**PROJECT NO. ST87600114-3
GRAND CANAL BIKE AND PEDESTRIAN IMPROVEMENTS
FEDERAL AID NO. PHX-0(BFG)F**

ADDENDUM NO. 5

ISSUE DATE: September 20, 2017

TYPICAL SECTIONS

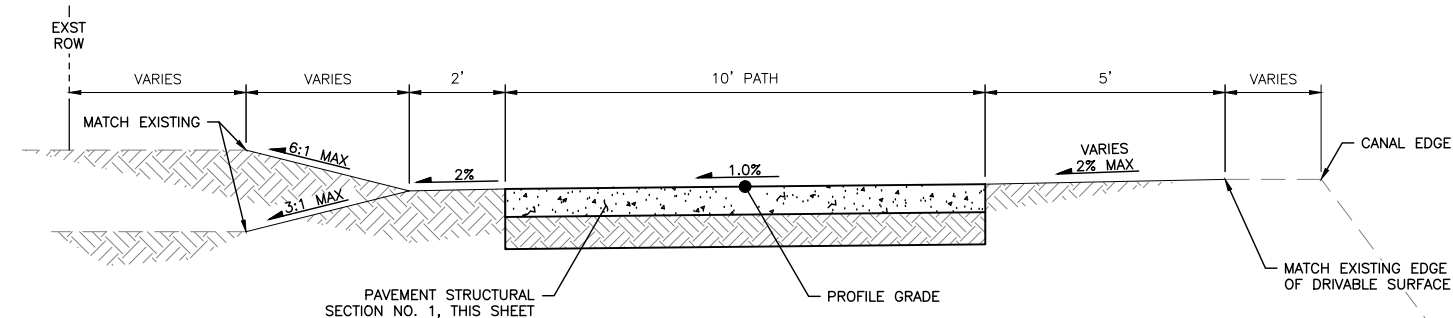
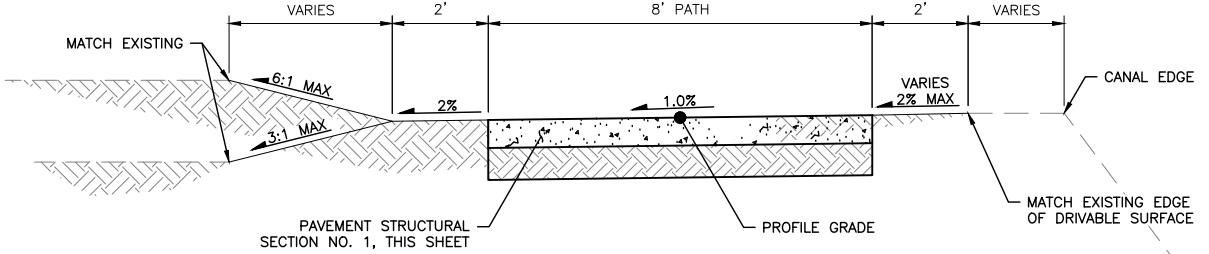
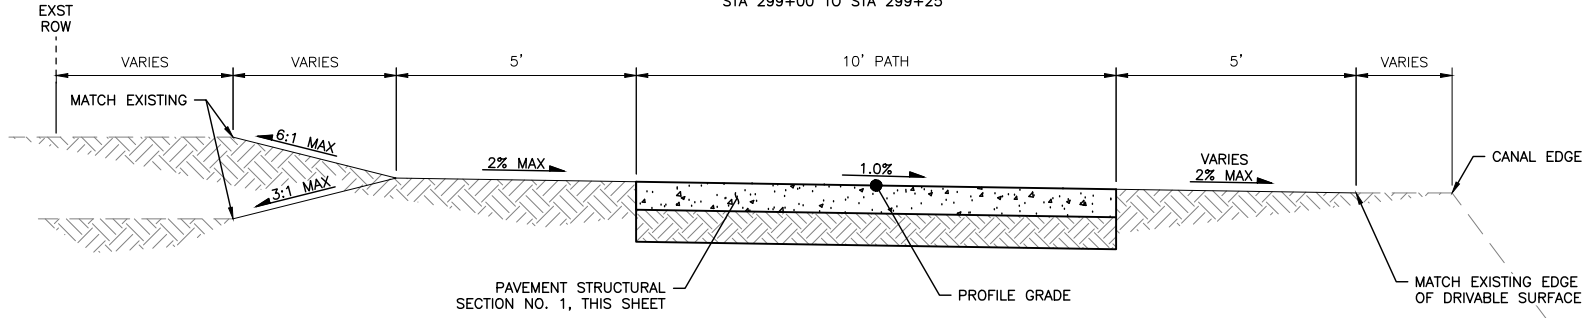
A9.	Please see Addendum 4.
Q10.	Item 6.18 – Plan sheet 2.164 shows an "SQ" foundation on the proposed foundation schedule however on the Hawk Equipment Notes the plans are calling for an ADOT Type W Pole. What is the correct pole for this location?
A10.	The correct pole and foundation is an ADOT type W pole. See updated foundation schedule.
Q11.	Plan sheet 2.169 shows conflicting information. Please confirm bollards or light fixtures on 15' poles.
A11.	Those are bollard lights and should have been note 5. See revised sheet SE2.3.
Q12.	Volume 2 Page 2.003 shows a table of bid items and quantities. Item # M3400407 calls for Concrete Sidewalk with WWF (welded wire fabric). Similar bid items for the path for example ex. Volume 1 page 1.04 calls for Concrete Sidewalk Std Detail 1230 7" thk

Class AA. The pavement section drawings call out PCCP, not sidewalk. Is this path PCCP or sidewalk? Is WWF required.
A12.	Pathway shall be Concrete Sidewalk Std Detail 1230 7" thick Class AA. See revised Sheets 3.05
Q13.	Will the joints for the path be tooled (Sidewalk) or can they be sawcut (PCCP)?
A13.	Construction of joints shall be per Std Detail P1230.
Q14.	The material is called out as weathering for the structure, mesh, and bar grating. However later in the specifications, it mentions "colorant for galvanized metal" and mentions Natina Stain. What is the finish for the bridge? If galvanized and stained, are we still required to use A588 material instead of the standard A500?
A14.	See page S.P. – 70 of the special provisions for the material requirements of the Prefabricated Steel Bridge. The material requirements listed on page S.P. – 71 and 72 are applicable to the Steel Handrail details located on Sheet 2.127.

7" CONCRETE PATH PER COP STD DTL P1230 MODIFIED CONCRETE SIDEWALK, CLASS AA

8" COMPACTED SUBGRADE, FILL OR SCARIFIED & RECOMPACTED NATIVE SOIL, 95% COMPACTION PER MAG 301

4 SQUARE CONCRETE POLE AREA LIGHT DETAIL
NO SCALE

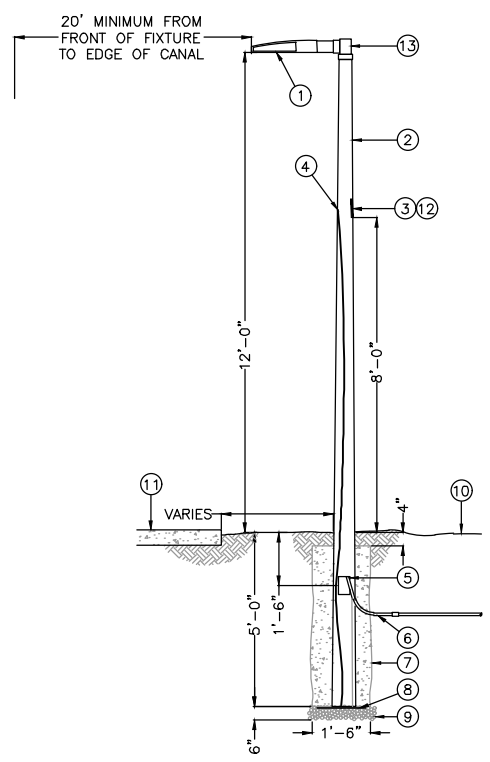
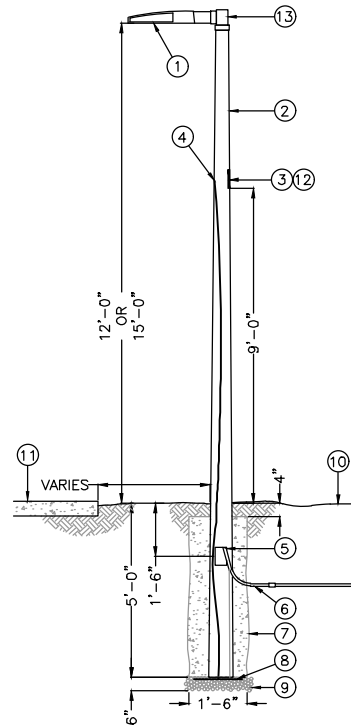
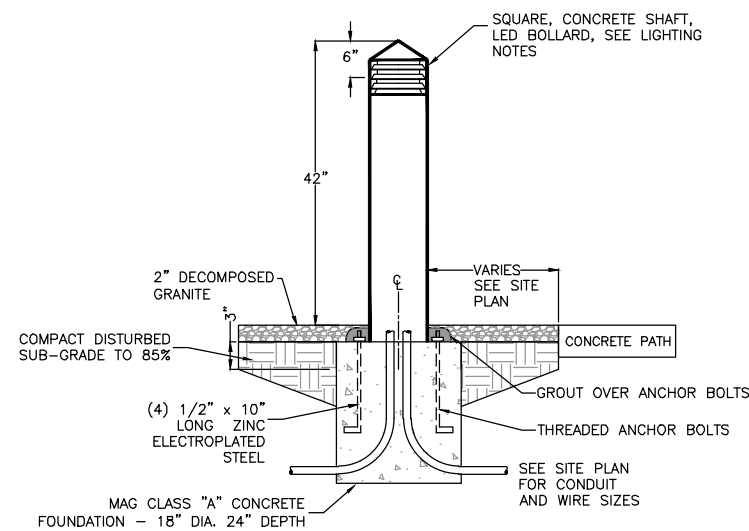
REVISION BY CITY OF PHOENIX	NO.	DESCRIPTION	REV BY	CHK BY	DATE
		APPENDUM 5	DVG	CMT	9-17
